SIB 61 06 22

RECALL 22V-672: REPLACE HORN MOUNTING SCREW

2022-09-09

Model	Model Description	Production Date
K07	CE-04	8/31/21-8/29/22

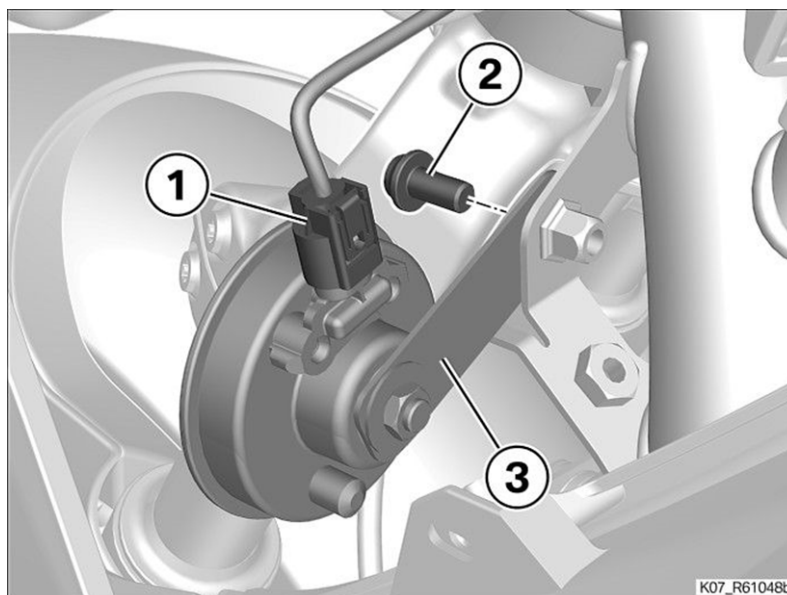
The Screw (Item 2) of the screw connection to the frame is short. Under certain circumstances the screw may come loose and drop down causing a restriction in the left turn steering angle.

The short screw for attaching the horn must be replaced with a new longer screw, according to the repair operation "61 33 011 Replacing the horn".

07 12 9 908 415	Fillister-Head Screw M8x20-8.8-MK
-----------------	-----------------------------------
